## HINCKLEY RAIL FREIGHT TERMINAL

Comments: Transport and Access

CPRE Leicestershire

Oct 2023

**Figure 5-7: Key Desirable and Undesirable HGV Routes**

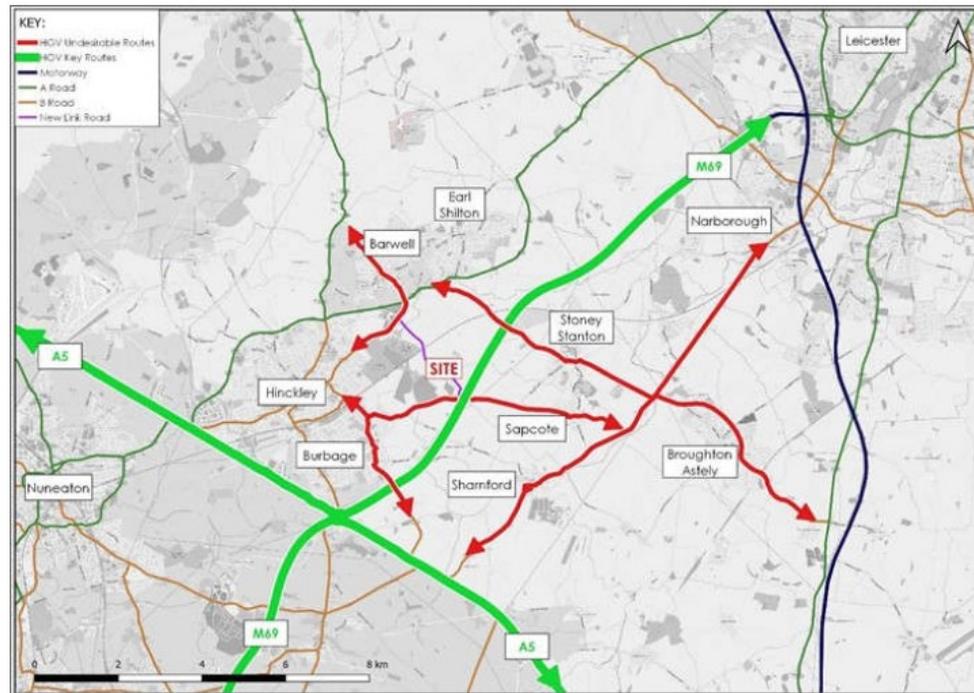
5.35 It is accepted that the proposed routing can only be advisory (Para 8.327 of the EA) and HGVs may use other routes, even when there is no incident.

5.36 Figure 5.7 identifies routes which it considers are undesirable for HGVs. Those include routes which even according to the modelling by Tritax will see HGV increases with the development in place according to Table 8.19 of the EA, such as the B4669 through Sapcote.

5.37 Clearly, the impact on these other roads will be much more serious at times when the M69 is not available and development traffic is diverted. This needs to be fully considered.
